Re: **Approved Jurisdictional Determinations, U. S. Army Corp of Engineers Permit SPL-2008-00816**

**Date:** May 5, 2021

**From:** Julia Fonseca, Environmental Planning Manager

**RE: Rosemont Mine Approved Jurisdictional Determination, U. S. Army Corp of Engineers Permit SPL-2008-00816**

Figure 10. Persistent flows at the USGS gage at SR83 in February-March 2019. Red dates are field measurements of flow by USGS, to verify the gage recordings.

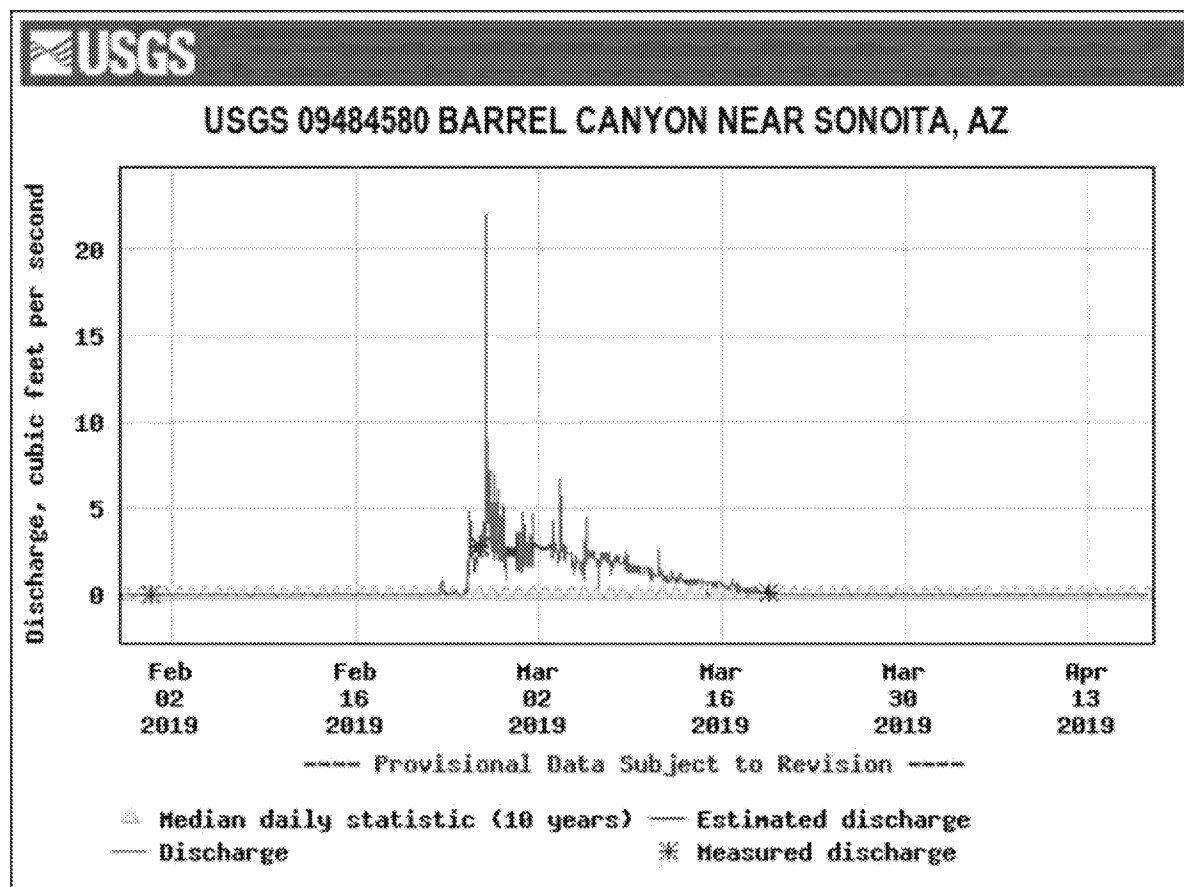
Figures 6-9 provide visual evidence of persistent, intermittent flows documented in the gage data that the Corps failed to review. There is no evidence that the agency examined any of the USGS' site photographs for corroborating evidence at the Barrel Canyon gage, let alone reviewing contemporaneous USGS field measurements of base flows for evidence of intermittency. Examination of USGS hydrographs of flow events from the gage can also be instructive and are readily available; these can be generated online. For example, Figure 9 shows small flows persisted for several weeks in February and March of 2019.

Sharp, short duration peak of over 20 cubic feet per second (cfs) is characteristic of direct runoff. This is superimposed on a long “tail” of base flows ranging from three or fewer cubic feet per second lasting several weeks. These lower, persistent discharges are characteristic of intermittent flows. Barrel Canyon is an undammed stream, and the Corps has provided no alternative evidence for upstream regulation or impoundment of flow that could cause these effects.

**Figure 11. Geologic map of the northern part of the Empire Ranch 7 ½ minute quadrangle, Pima County, Arizona, by C. A. Ferguson, 2009. Arizona Geological Survey Open-Filed Report 09-05, version 1.0. Blue arrows added to emphasize bedrock outcrops surrounded by sediment.**

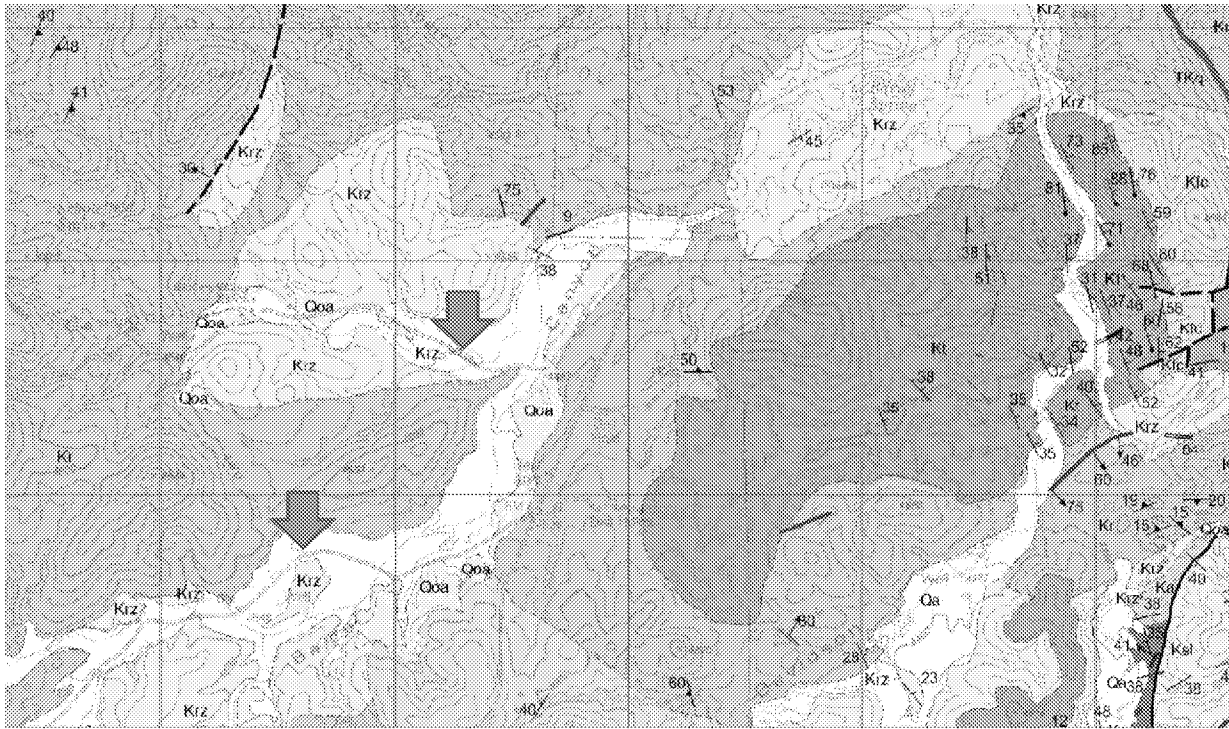
The Corps relied on disruption of flow at the bridge to account for persistent base flows and algae observed at the USGS gage. This interpretation ignores the hydrogeologic context of the Rosemont project setting.

This geologic map supports an interpretation of what hydrologists sometimes call a “shoestring aquifer” of Quaternary alluvium overlying bedrock of Cretaceous (K) age. Shoestring aquifers are narrow “strings” of loose sediment surrounded by bedrock, usually corresponding with the boundaries of the geologic floodplain. Because of their small size, they can quickly fill and drain. In Figure 11, sediment, as known as alluvium, is shown in yellow. The other colors are bedrock. Note the occurrence of small green Cretaceous (Krz) outcrops surrounded by the yellow alluvium in Scholefield and Barrel Canyons upstream of the SR83 highway crossing. The arrows show bedrock “peeking” through thin sediment. Even more important, the geologic map shows that yellow alluvium is absent just downstream of the highway; here the stream flows over a mass of green and pink color representing bedrock. This is the end of the “shoestring”.

Figure 12. Drill log of alluvium over bedrock encountered at Huidbay monitor well BC-2A, the alluvial piezometer, figure from m Hydro-Logic (2013).

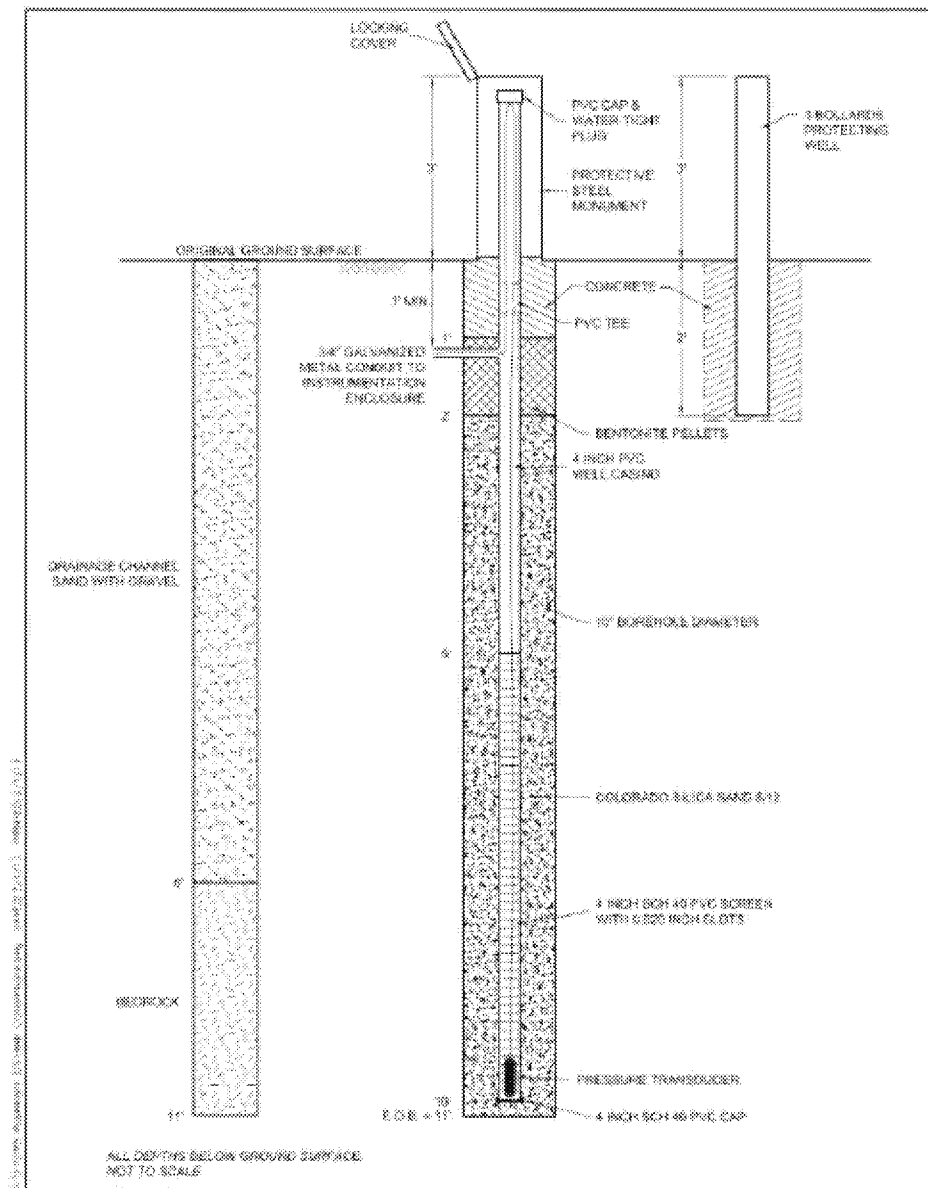
In fact, bedrock lies only eight feet below land surface at the Hudbay monitor well located approximately 0.3 miles upstream of the USGS gage on Barrel Canyon (Figure 12), and bedrock outcrops just downstream of the USGS gage (Figure 13). Intermittent flow likely occurs when the shallow alluvial cover is sufficiently saturated upstream of the big green mass of bedrock, much like water spilling over the lip of a cup.
